Optical specifications updates for 800GBASE-LR1 & 800GBASE-ER1

Supporting Comments 385, 386, and 388

IEEE P802.3dj

July, 2025, Madrid, Spain

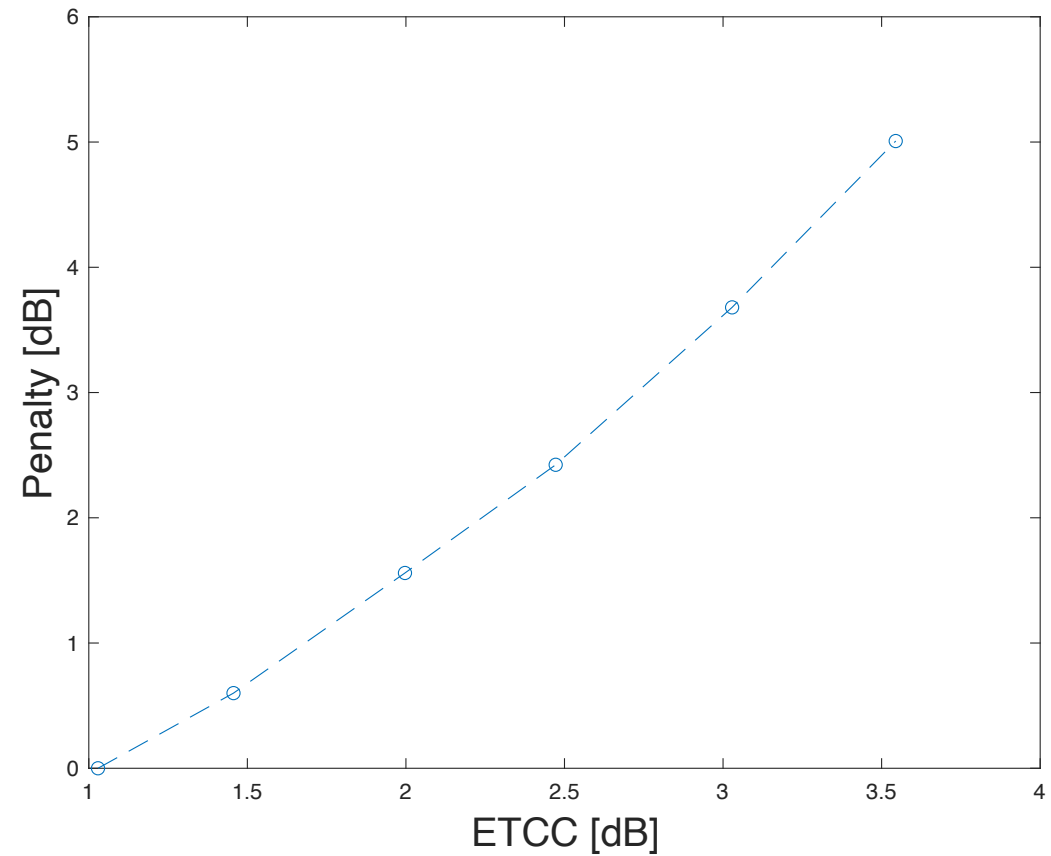
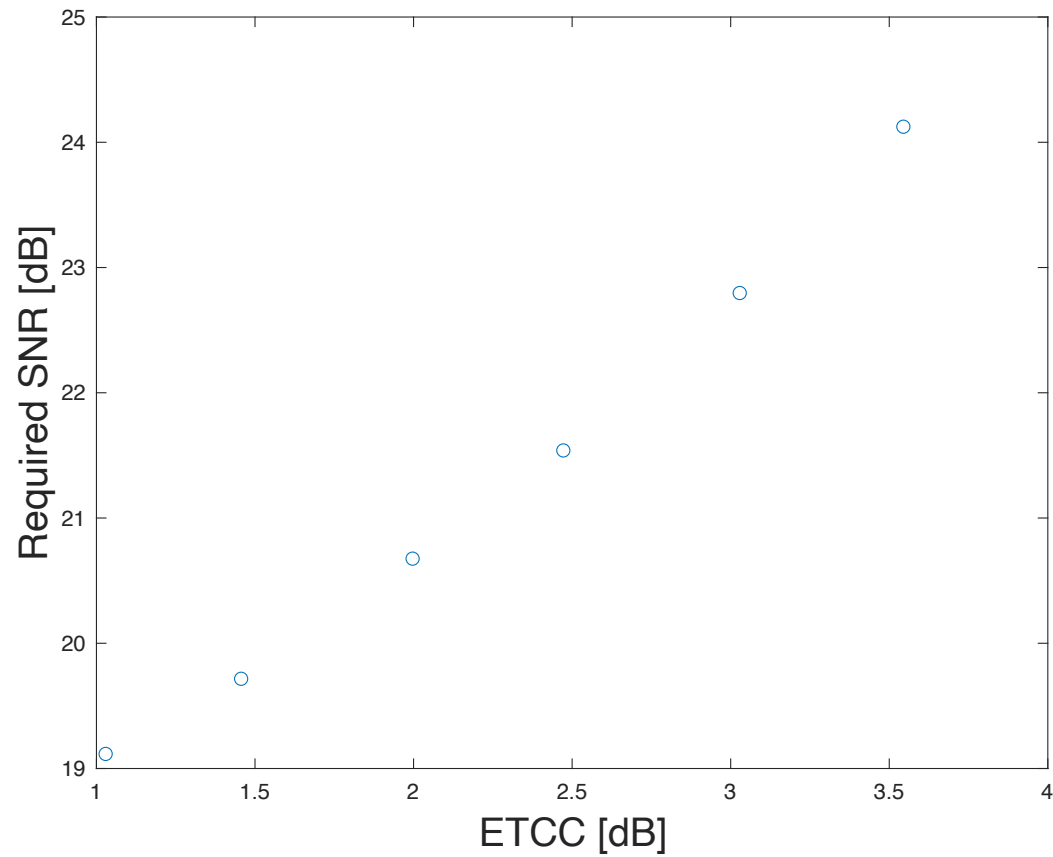
Penalty is calculated relative to RSNR at $P_{\text{input}} = -18\text{dBm}$, ETCC = 1dB

Although power increases with ETCC, a penalty with increasing ETCC is observed

SNR requirement vs Rx IMN

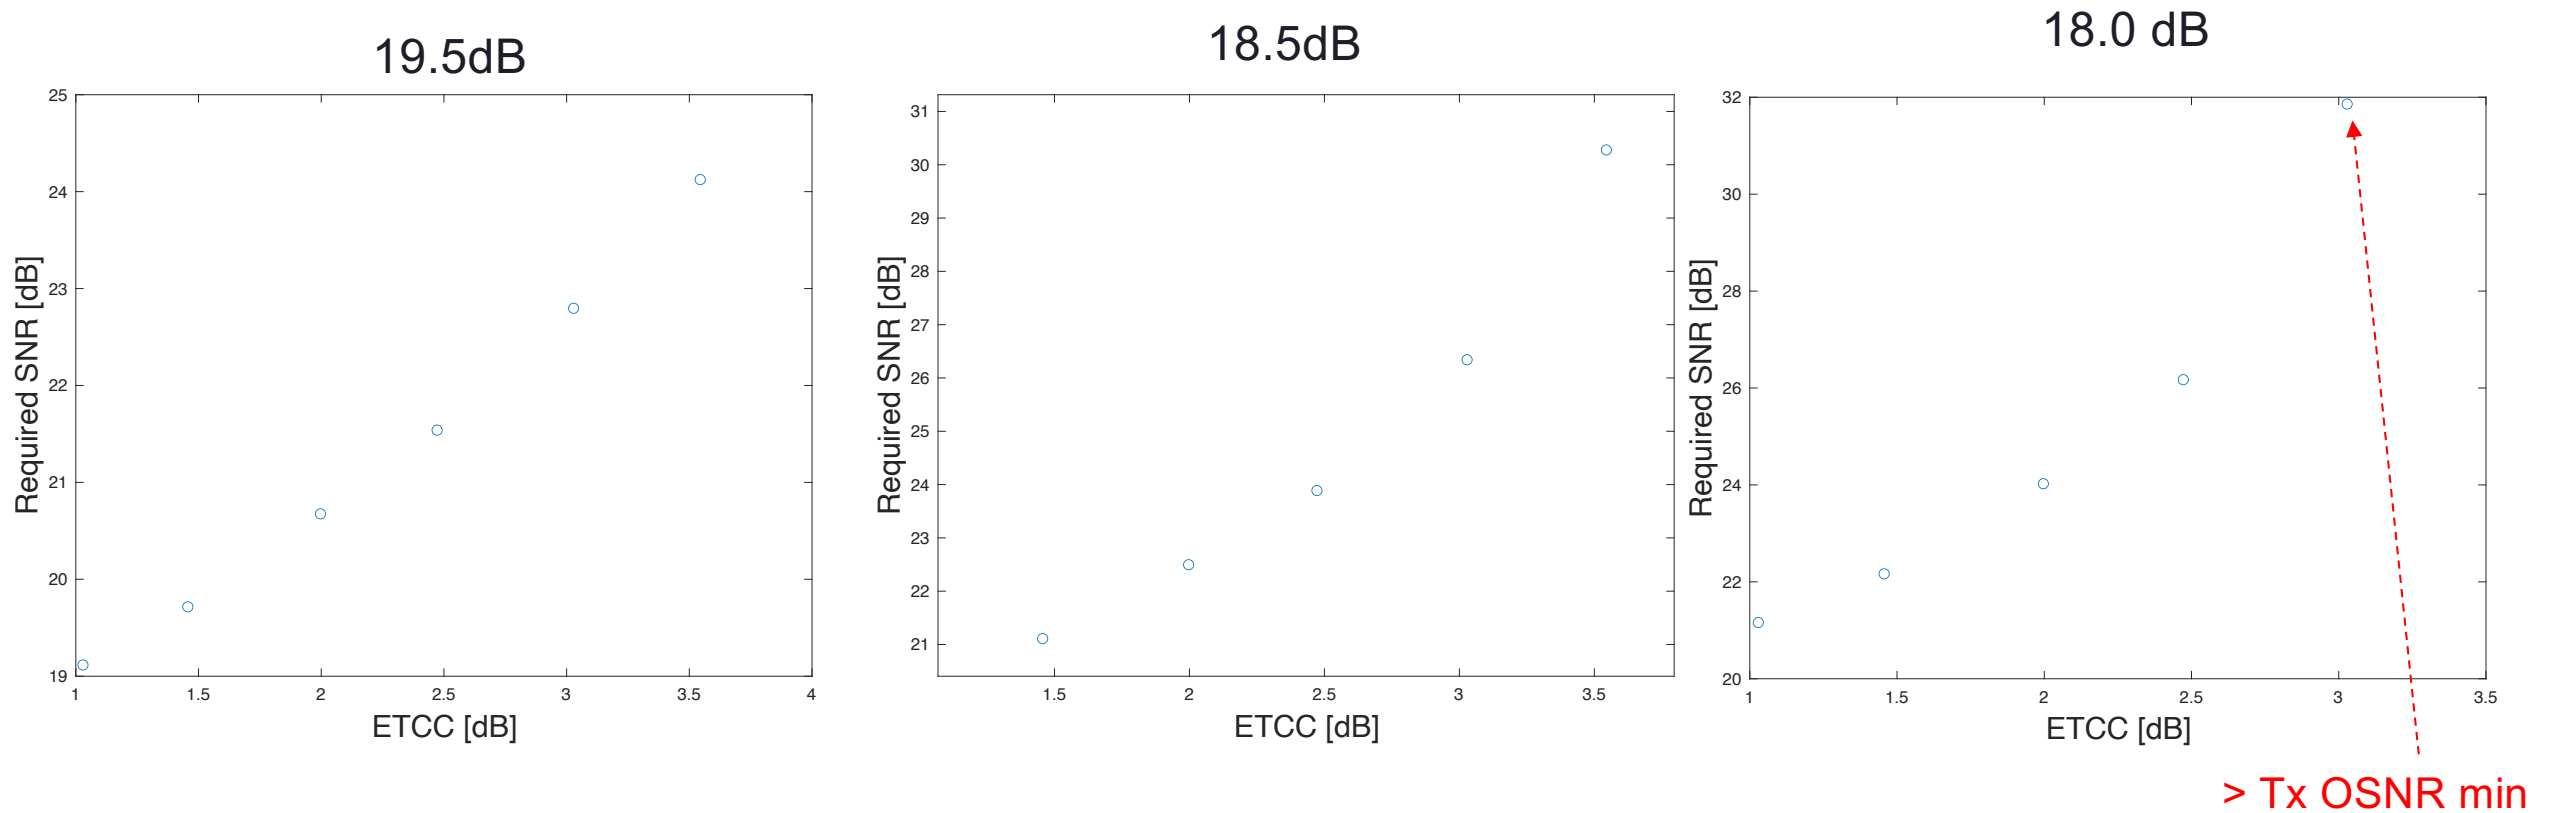
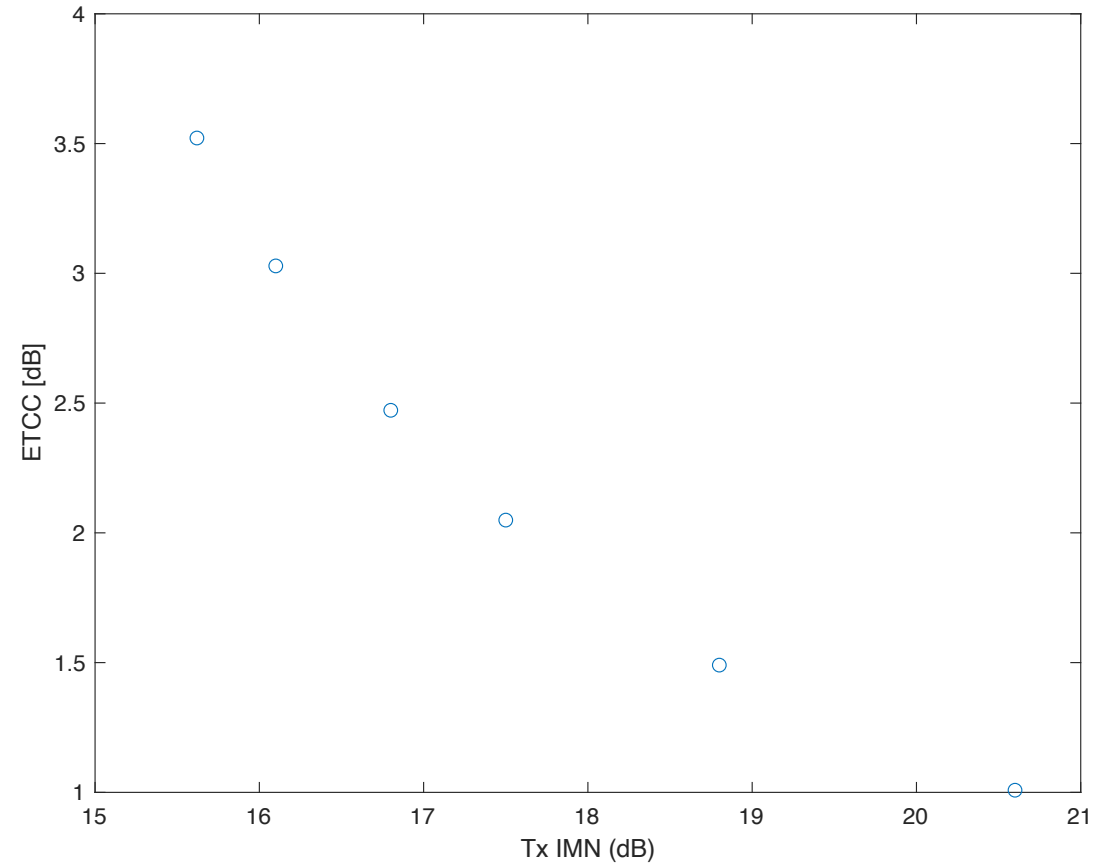
For an 18dB Rx IMN, even with power adjustment, ETCC > 2.5dB results in an unrealistic OSNR requirement

At this limit, internal noise sources account for the entire SNR budget

800GBASE-ER1 SNR vs Rx IMN

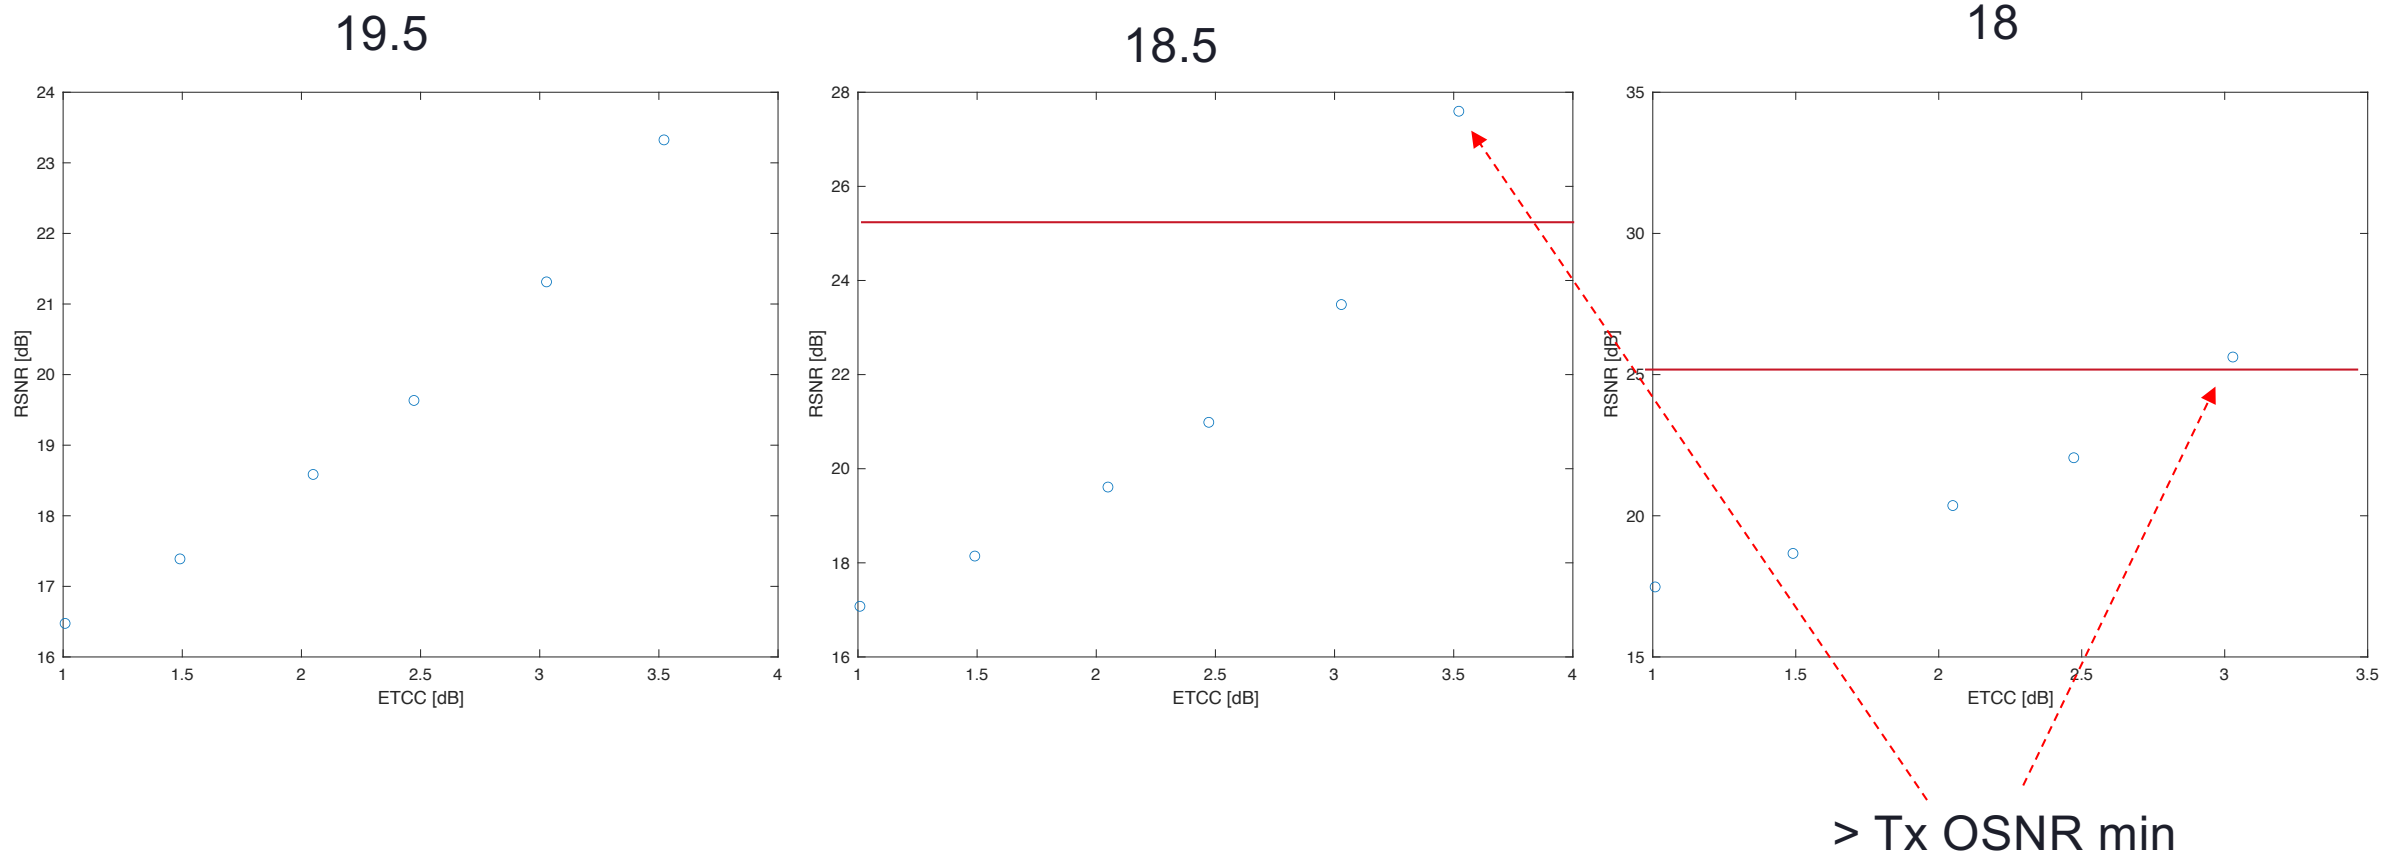
Conclusions from 800GBASE-LR1 hold for 800GBASE-ER1: 2.5dB ETCC Max is appropriate for 800GBASE-ER1
